*Bridge Preliminary Design Report
Addendum*

**SR-823 over Norfolk Southern Tracks & US-23
SCI-823-1601**

**SCI-823-10.13
PID No. 79977**

DESIGNER RESPONSE TO REVIEW COMMENTS

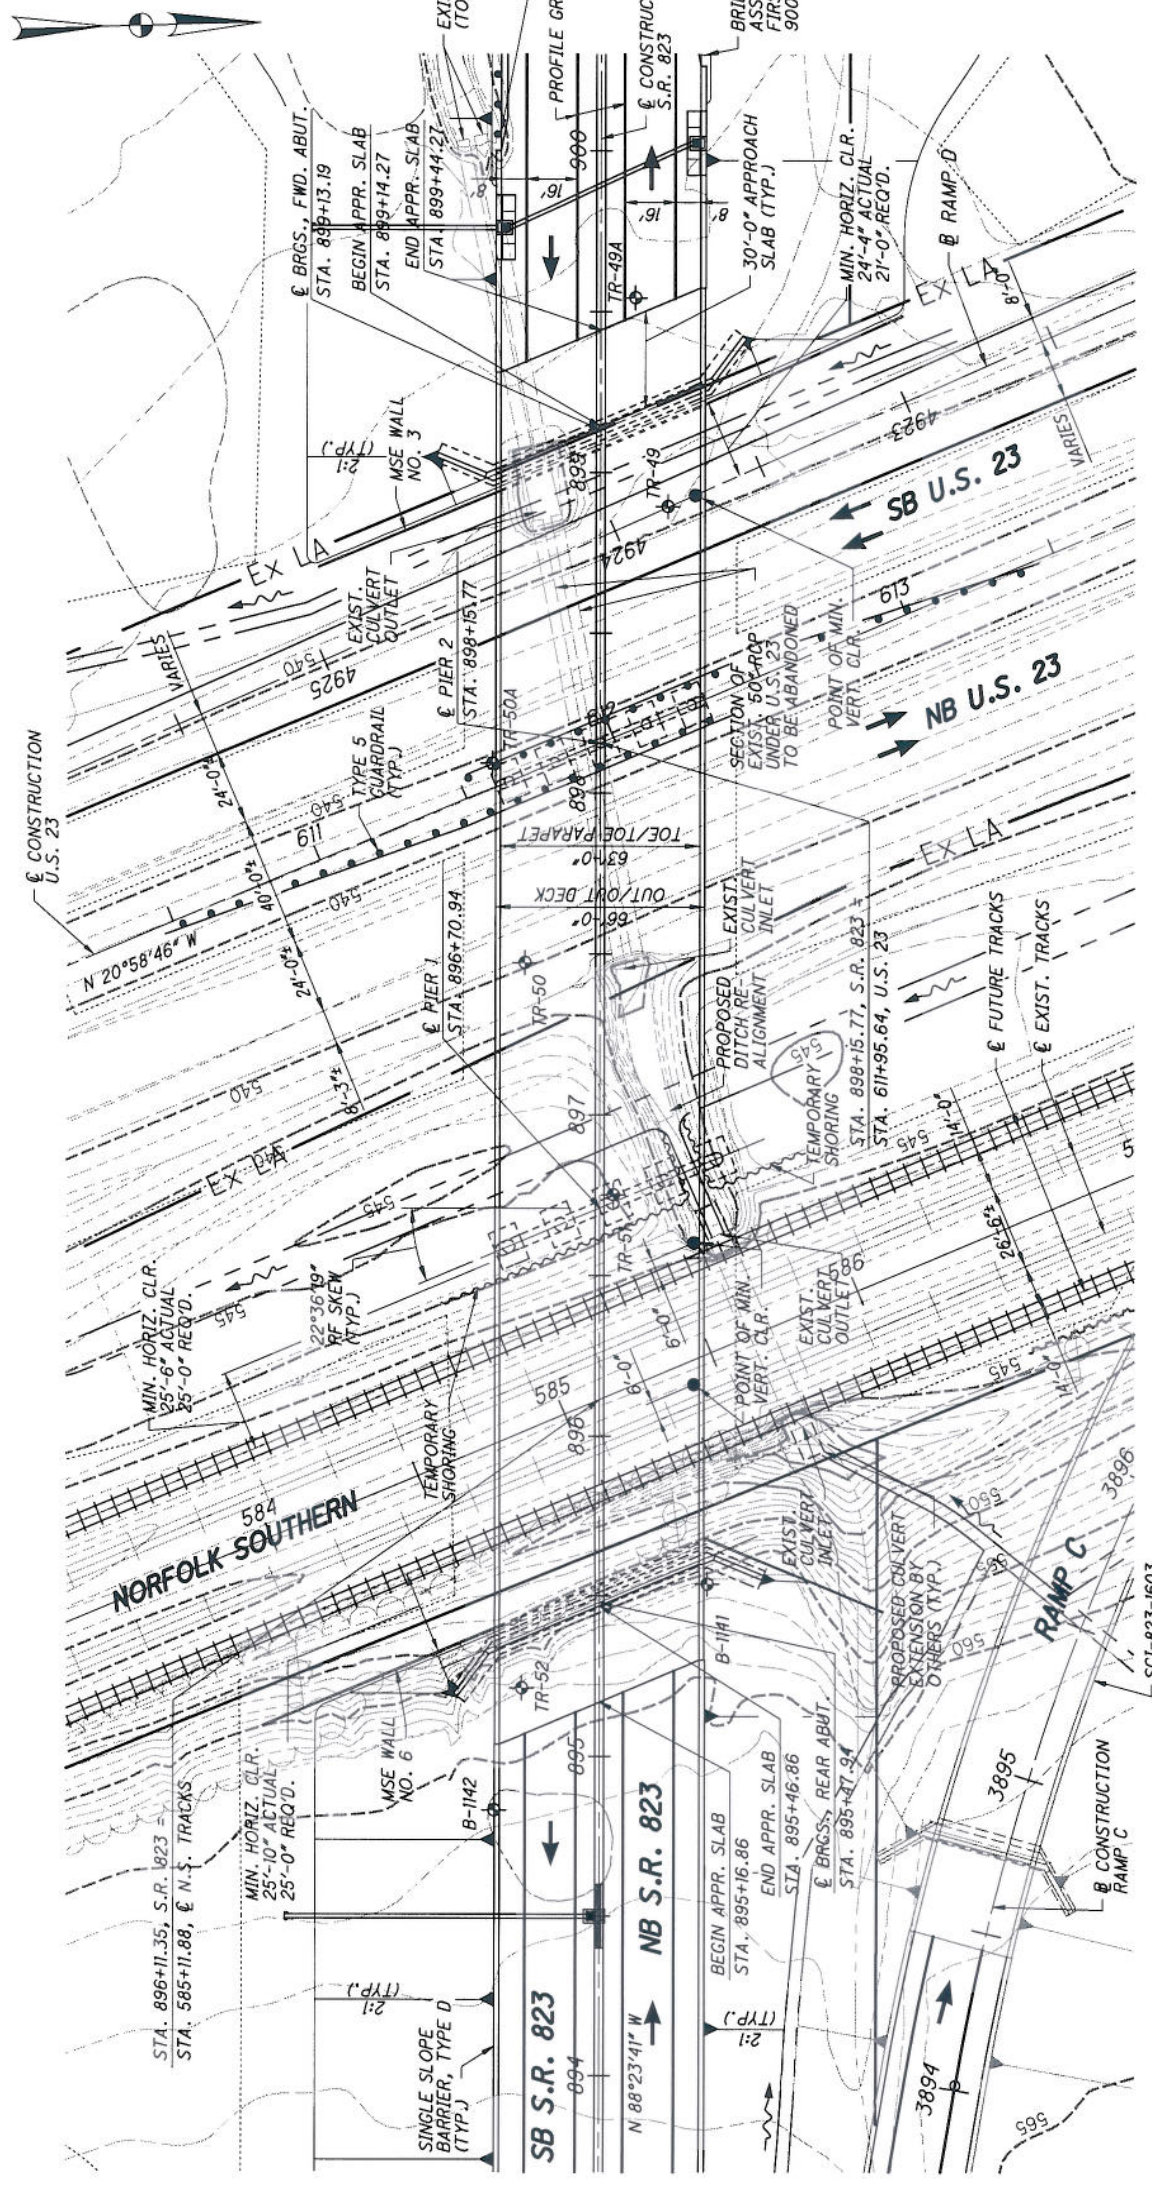
As discussed, your interpretation is somewhat confused. The T portion of the cap can not be any closer to the track than 10'-0" if bottom portion is less than 23'-0" above top of rail.

One thing of note is the location of the T-type pier. Our understanding is that as long as the pier stem is a minimum of 22'-0" from the centerline of the track and 10'-0" high, the pier cap can extend inside of the 22'-0" clearance envelope. Again, due to the two new tracks and the curvature of the ramps, our goal is to shorten the span lengths as much as possible.
